**City of Ketchum  
Planning & Building**

**STAFF REPORT  
KETCHUM PLANNING AND ZONING COMMISSION  
REGULAR MEETING OF JUNE 13, 2023**

- PROJECT:** Miller Residence
- FILE NUMBER:** P22-046 and P22-046A
- APPLICATION TYPE:** Mountain Overlay Design Review and Conditional Use Permit
- REPRESENTATIVE:** Aaron Bunse – Studio DVLP, LLC (architect)

- PROPERTY OWNER:** Paramount Property Development LLC
- REQUEST:** Mountain Overlay Design Review application for the development of a new 3,745 square foot single-family residence. A Conditional Use Permit application is also requested for the avalanche retaining wall located at the rear of the proposed residence.

**LANDSCAPE PLAN**

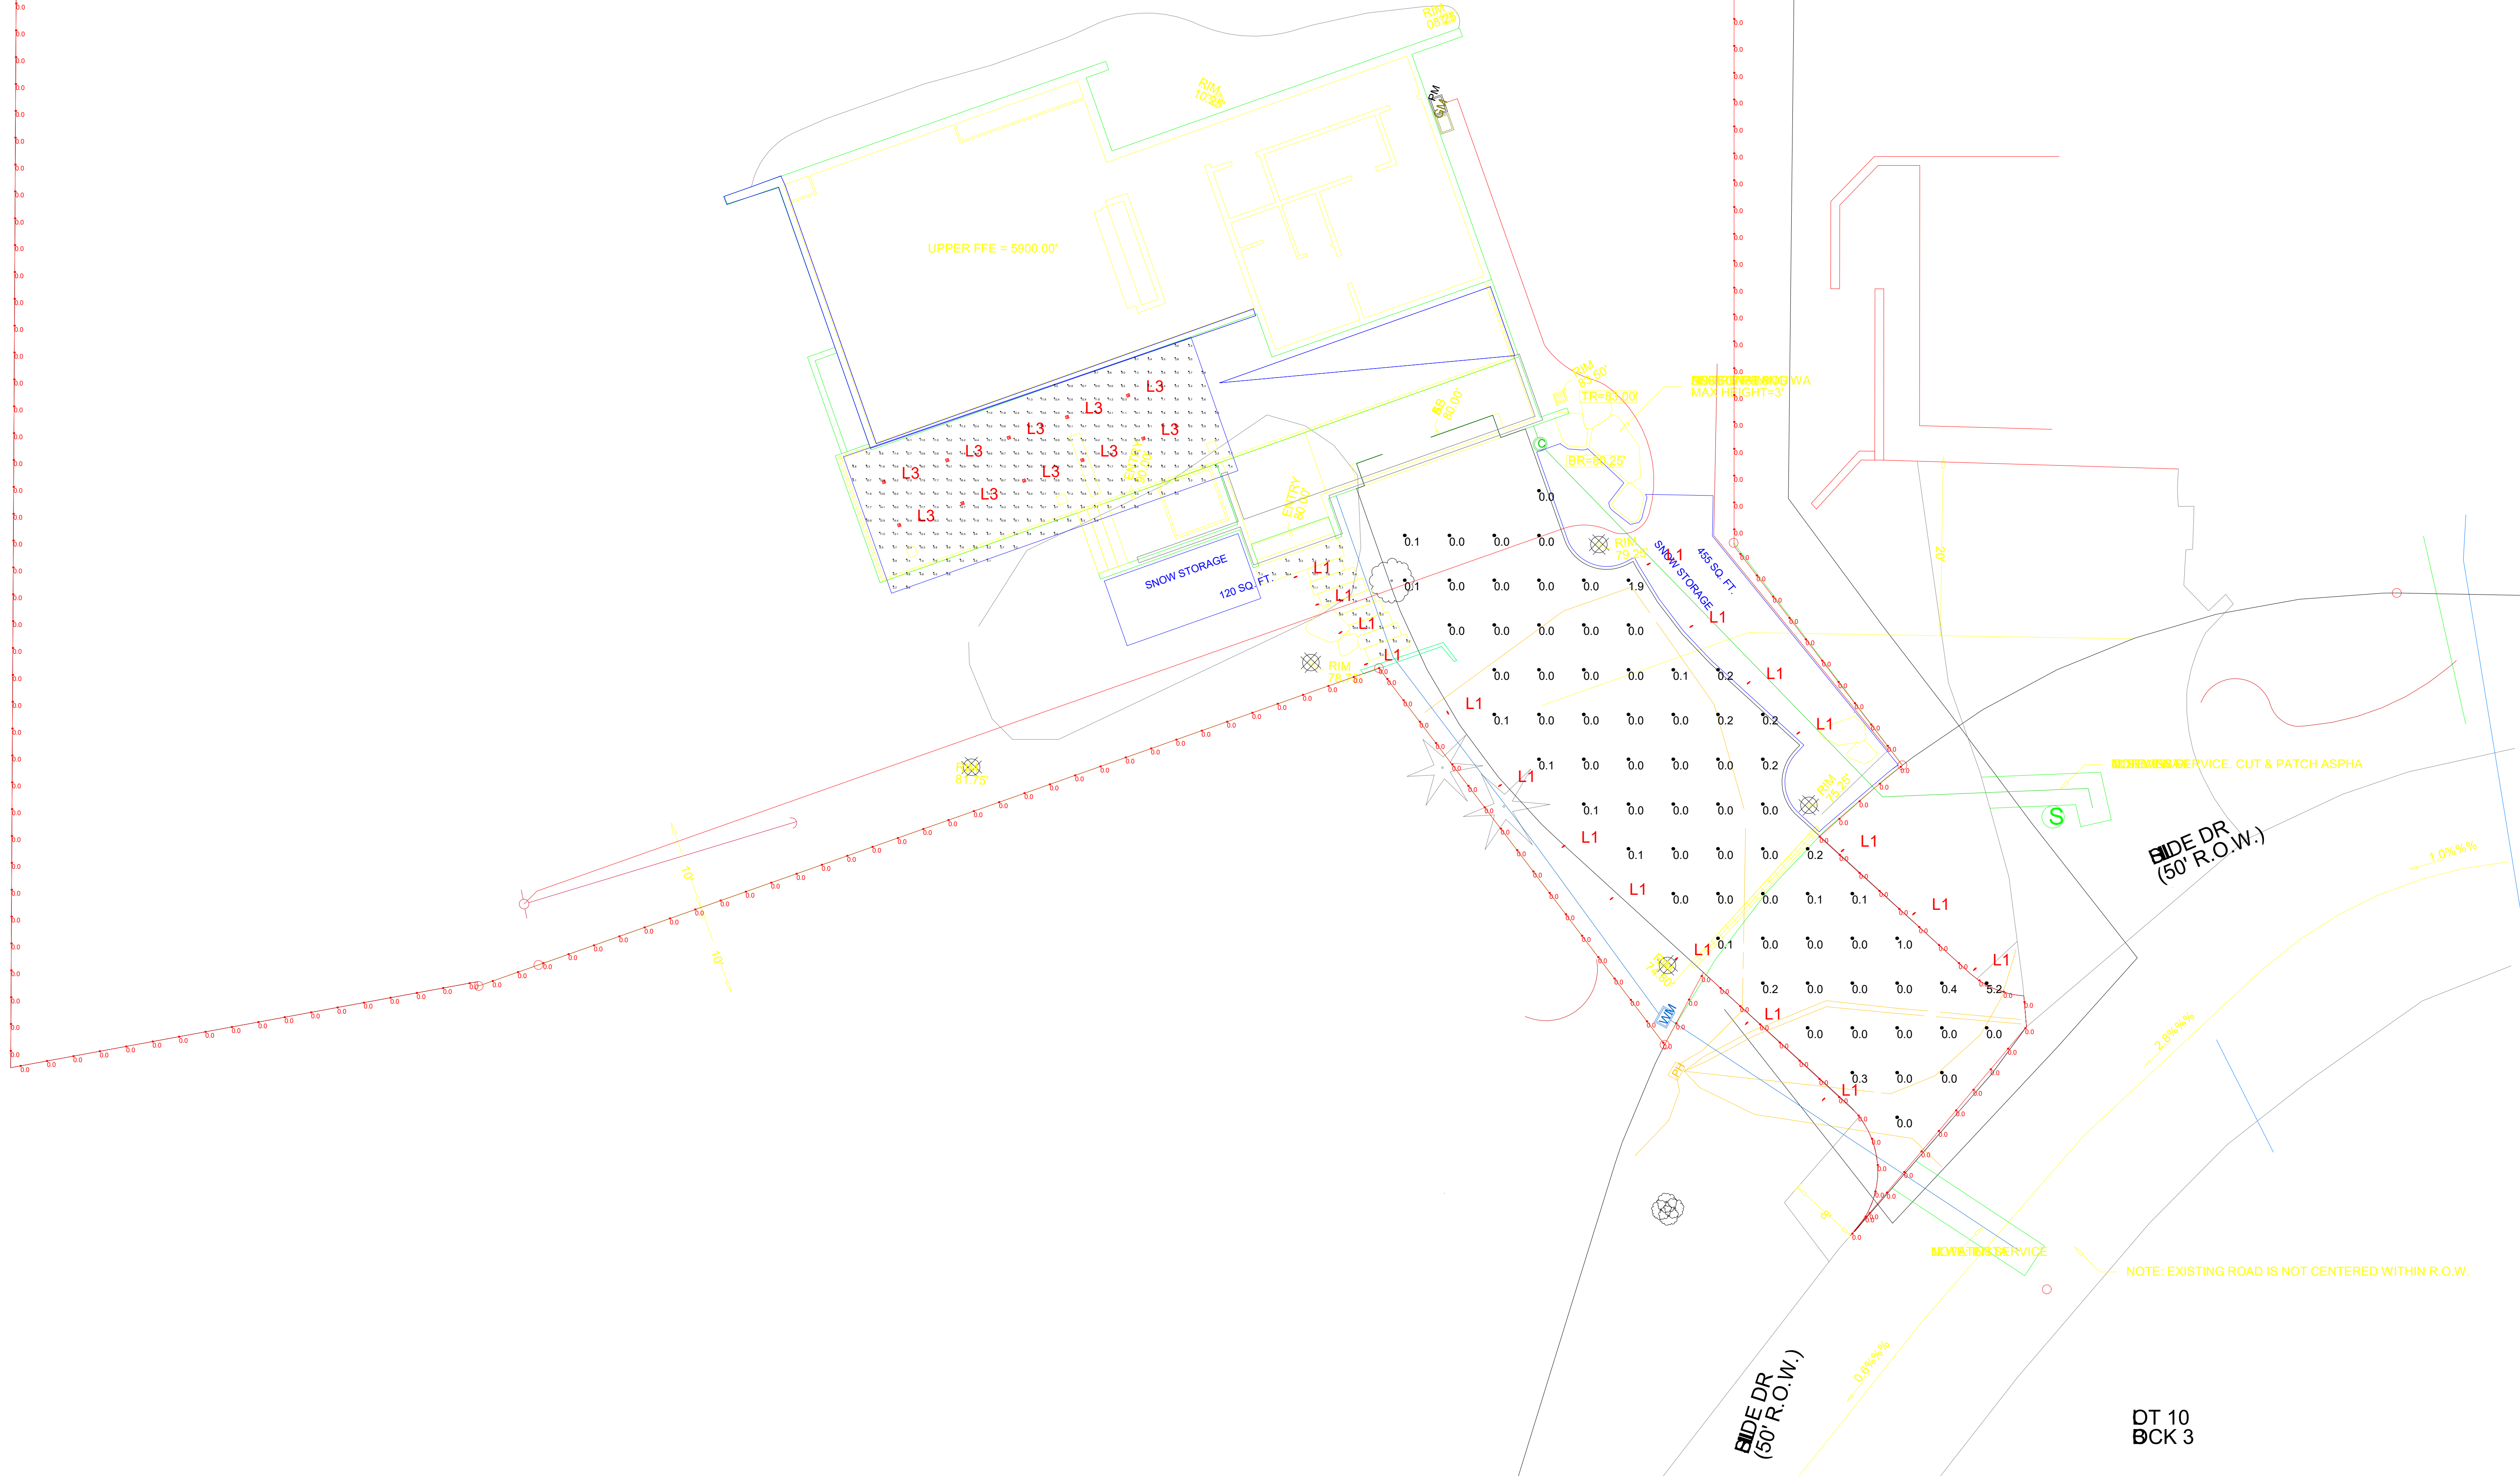
17.96.060.I.1 – Landscaping	Conformance
<i>Landscaping is required for all projects.</i>	YES
<b>Finding:</b> Landscaping has been provided for the project as indicated on Sheet L2 of the project plans.
